PROPOSED ALTERATIONS 40 MONASH PARADE, DEE WHY FOR CARYN CAVANAGH LOT 53A DP101690			
WEST, EAST & NORTH ELEVATION			DRG. NO. 08-16-MON
DATE AUGUST 2016	DRAWN J.WRIGHT	SCALE 1:100	SHEET NO. 3A

PROPOSED ALTERATIONS

40 MONASH PARADE, DEE WHY

SITE PLAN & CALCULATIONS		DRG. NO. 08-16-MON
DATE AUGUST 2016	DRAWN J.WRIGHT	SCALE 1:200
		SHEET NO. 5A

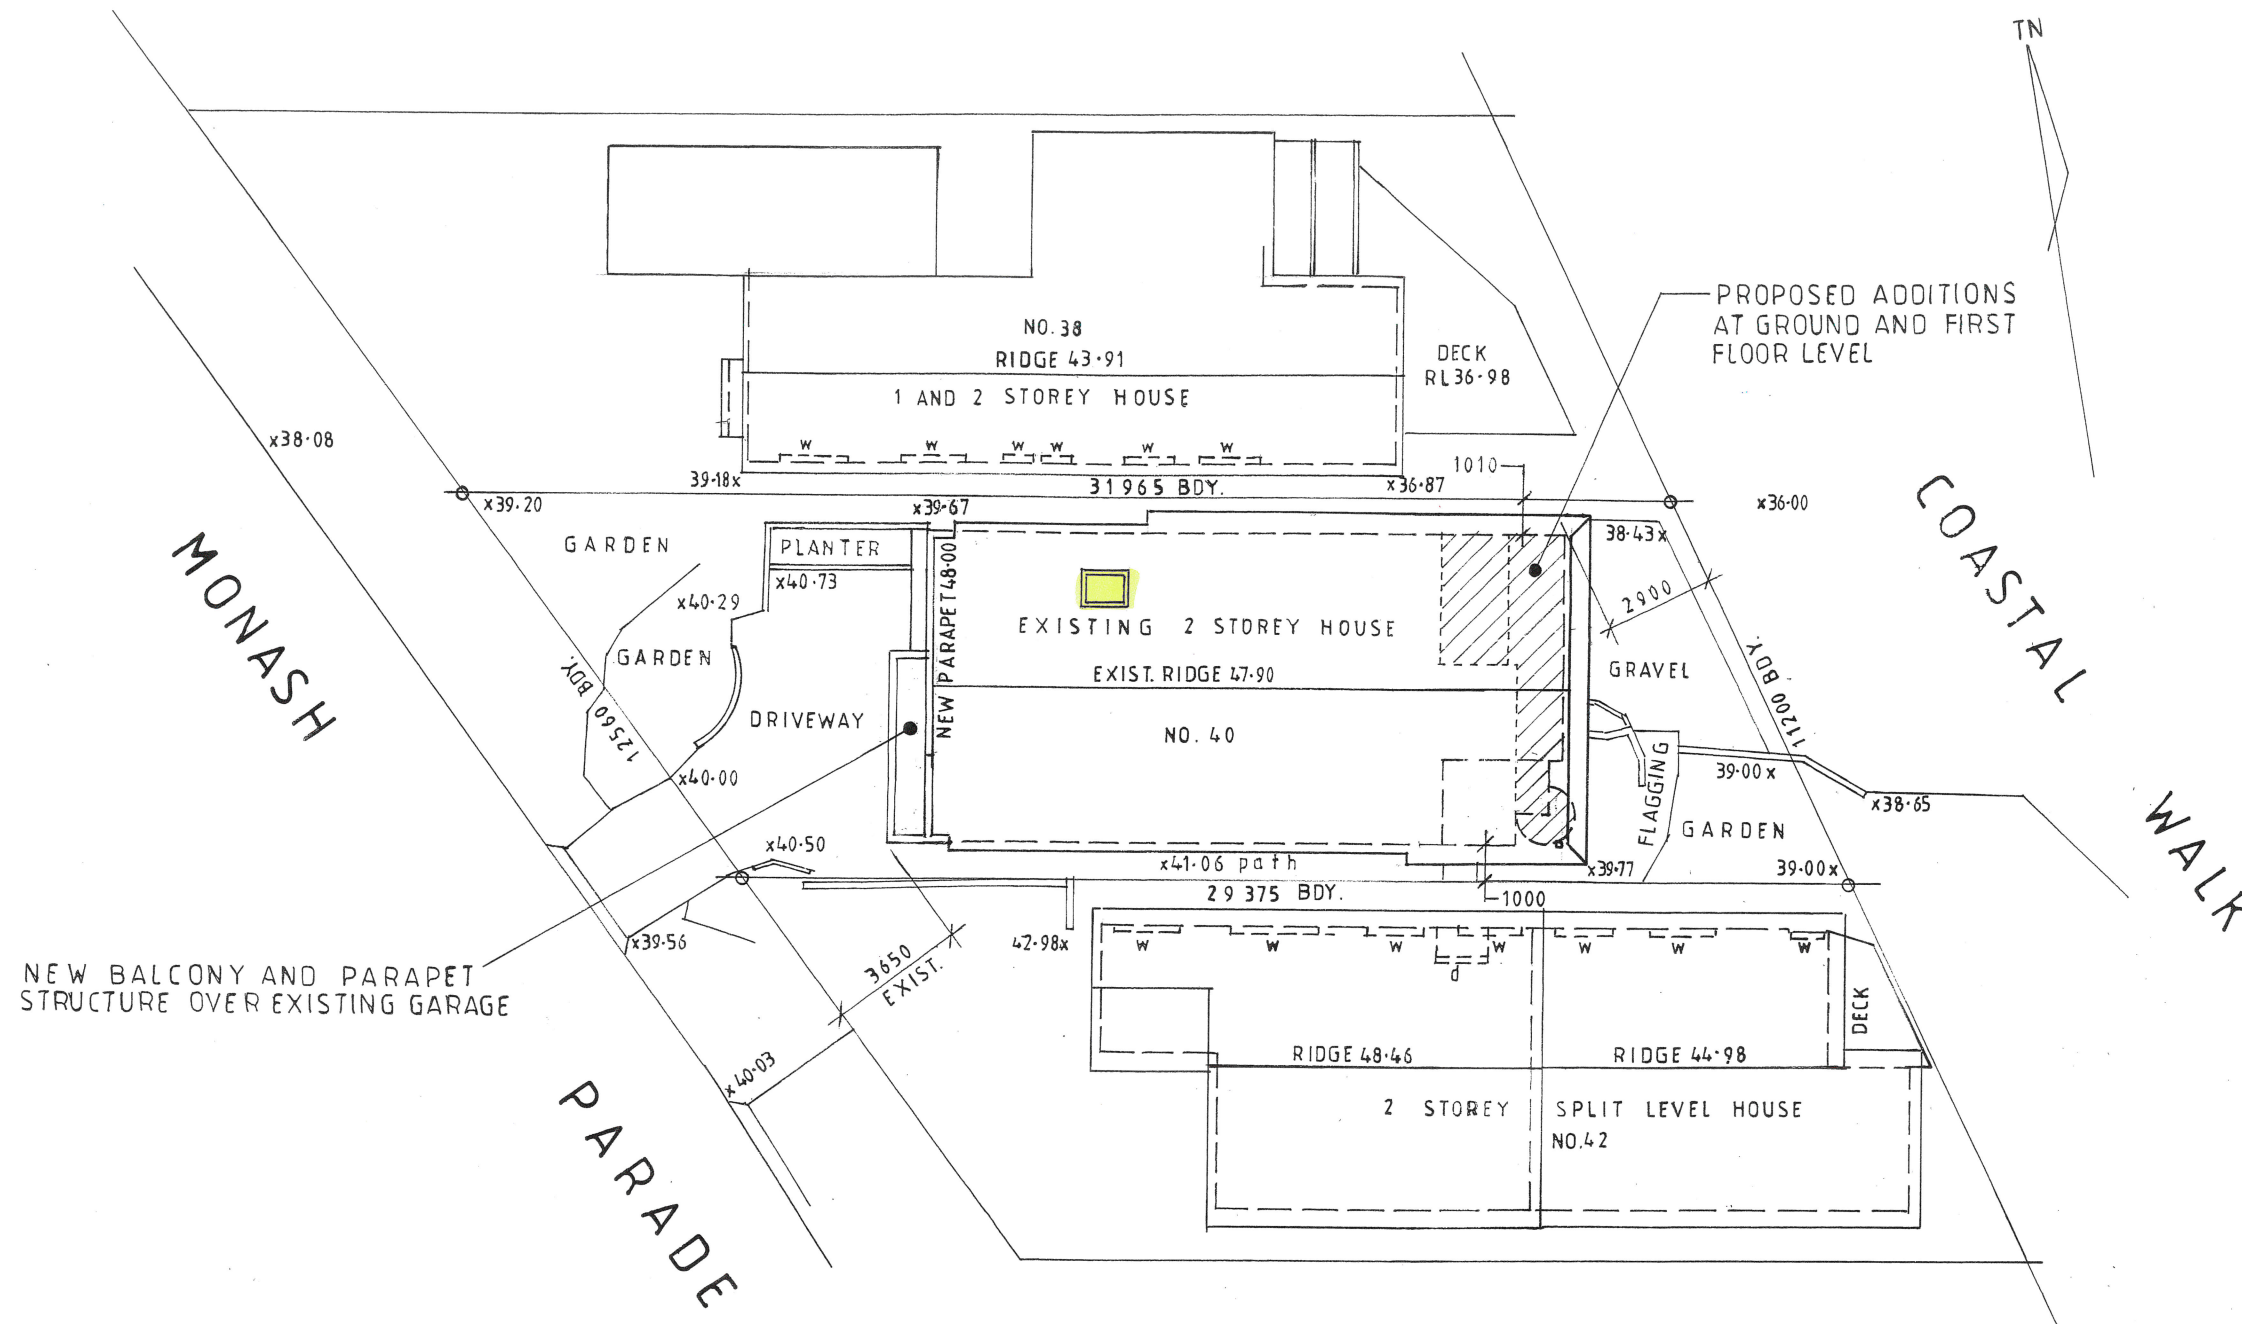
DATE	REVISION
A 12-11-18	SKYLIGHT ADDED
